FINAL PLAT OF
"SEERY'S' FIRST ADDITION"
AN ADDITION TO SEDGWICK COUNTY, KANSAS
IN THE SW 1/4 OF SECTION 34, T27S, R2E OF THE 6TH P.M.

RE: S/D 99-58 — One-Step Final Plat of SEERY'S 1ST ADDITION

RE: S/D 99-58 — One-Step Final Plat of SEERY'S 1ST ADDITION

CASE NUMBER: S/D 99-58 - SEERY'S ADDITION

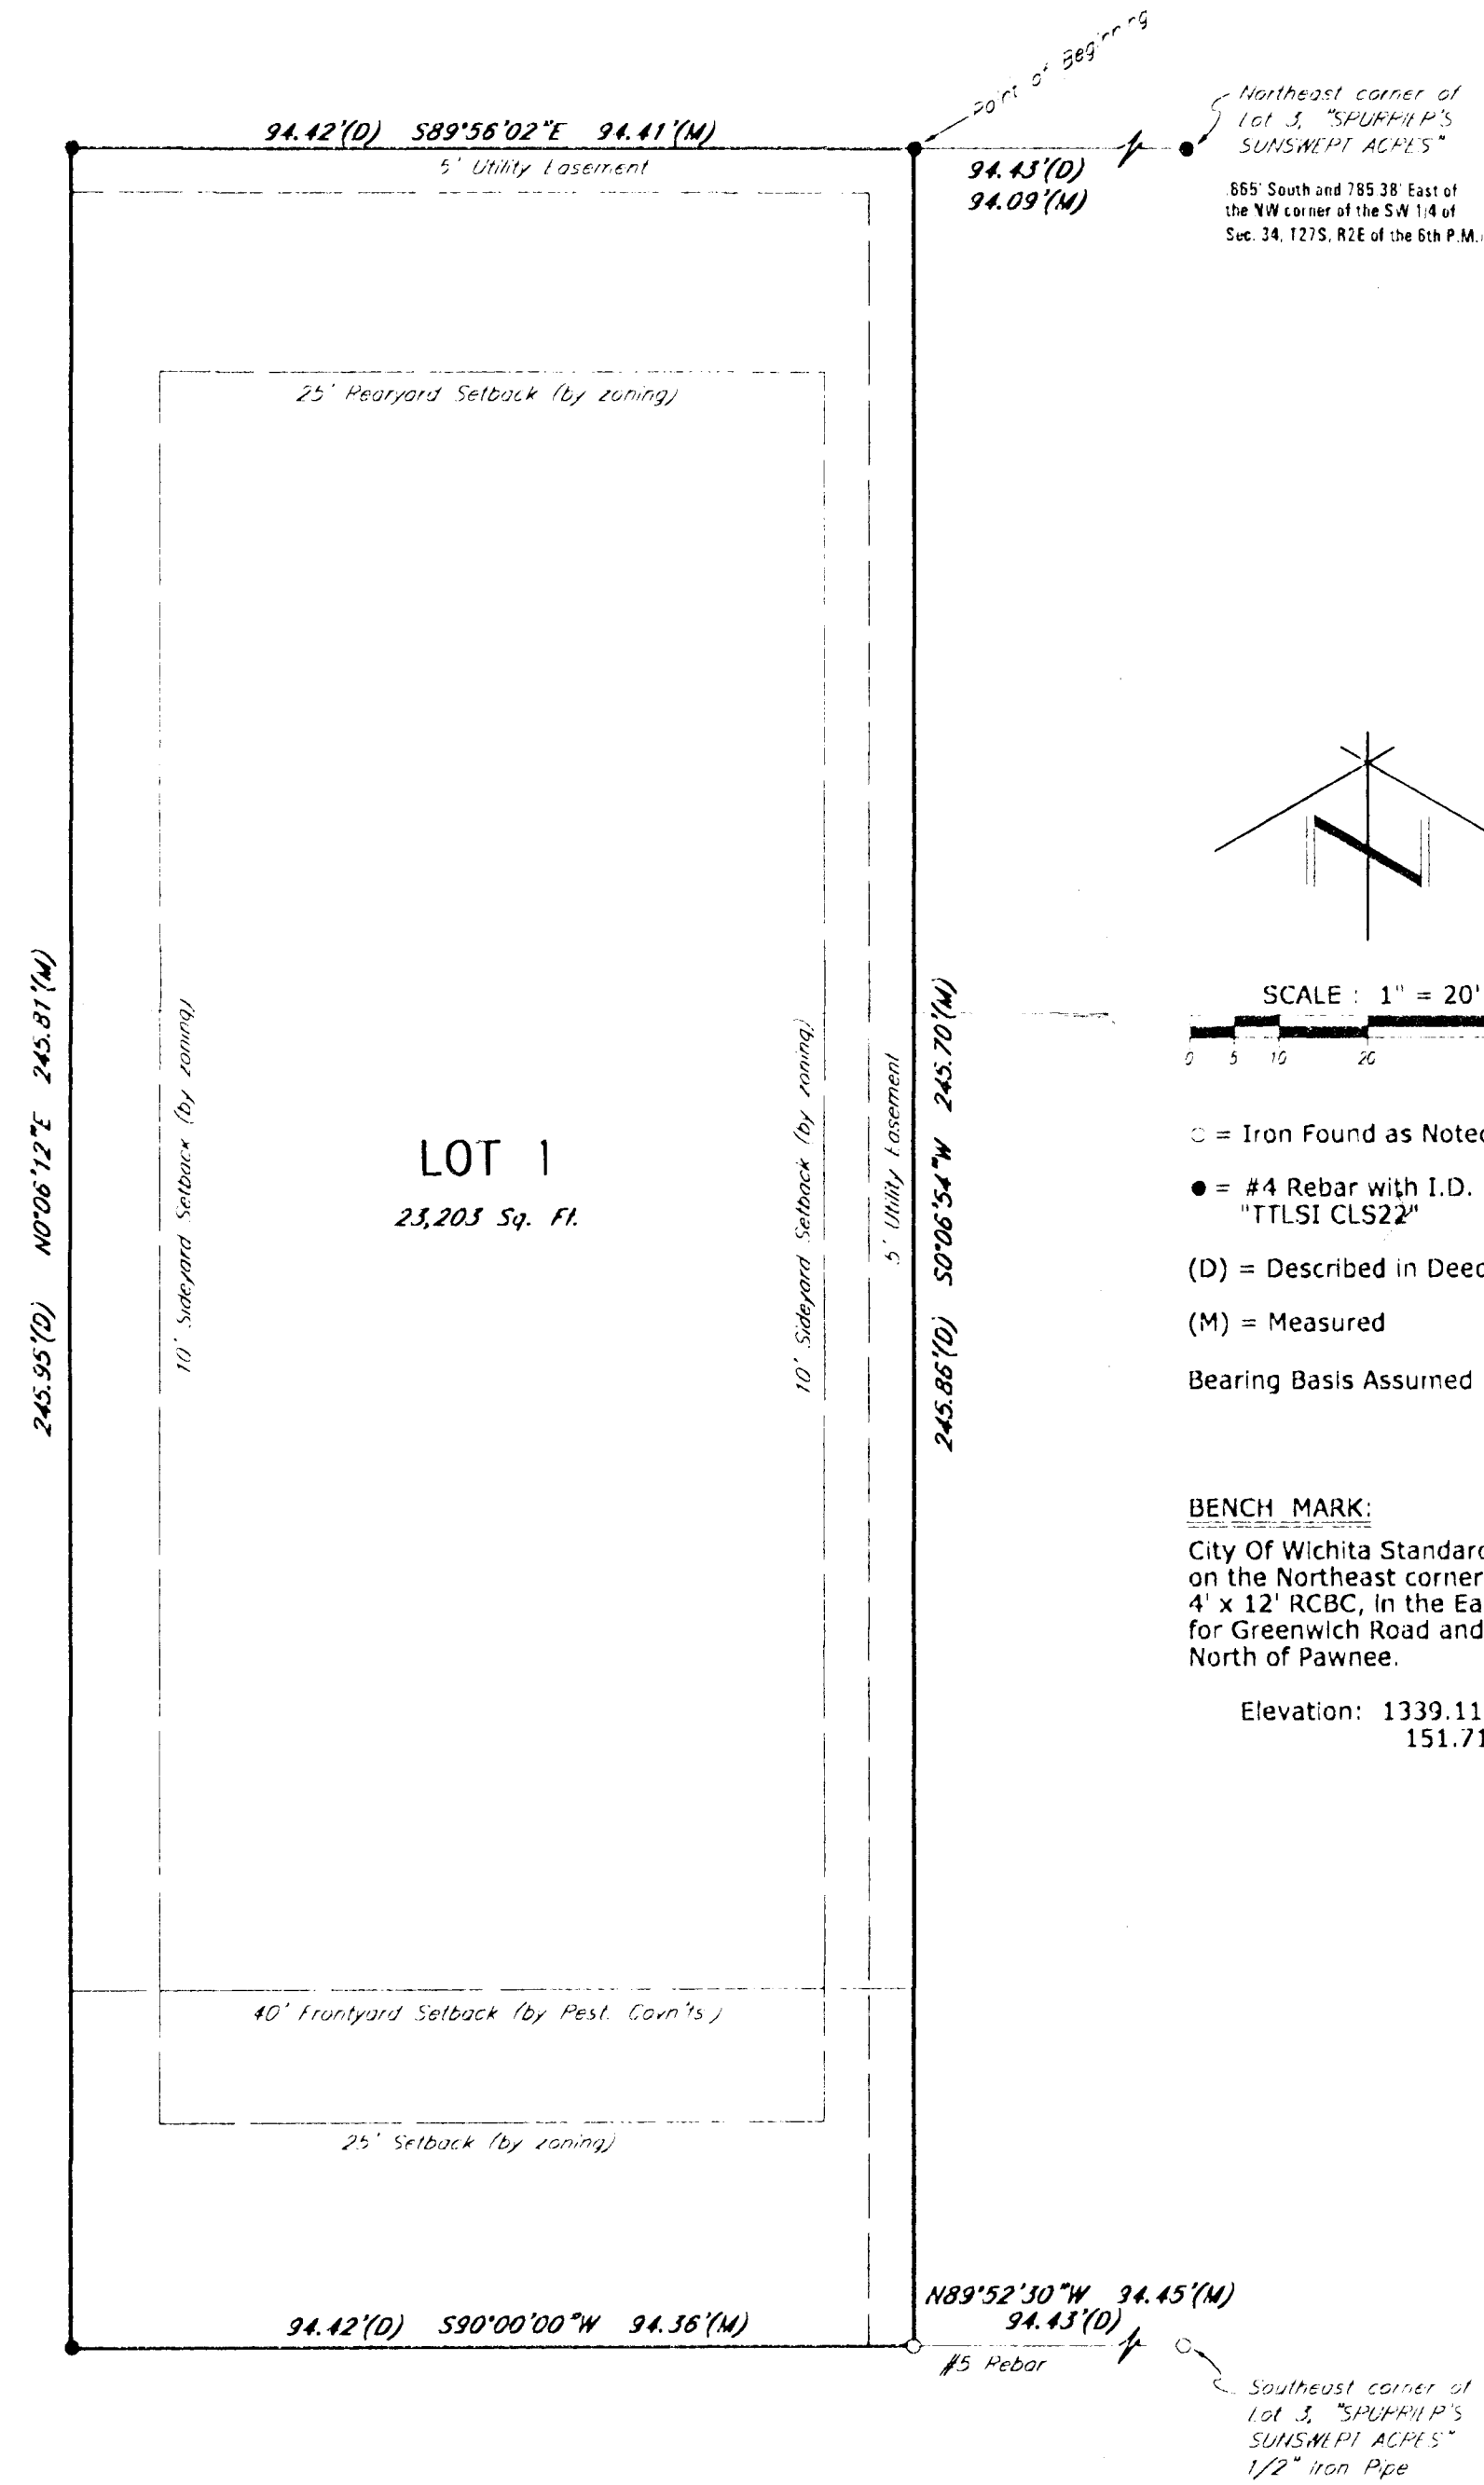
- D. County Engineering needs to comment on the status of the applicant's drainage plan. A four-corner lot grading plan is requested
- E. The plat contains less than the required 100-foot lot width and an administrative adjustment will be required.

- G. The name of the plat shall be corrected in the MAPC certification.
- H. The final plat tracing shall reference a tie point to a section corner.

- I. The lot depth exceeds its width by more than a ratio of 2.5 to 1, and a modification will need to be granted by the MAPC. The Subdivision recommends that this modification be granted.

- J. The plat's text shall include language that a drainage plan has been developed for the plat and that all drainage easements, rights-of-way, or reserves shall remain at established grades or as modified with the approval of the applicable City or County Engineer, and unobstructed to allow for the conveyance of stormwater.
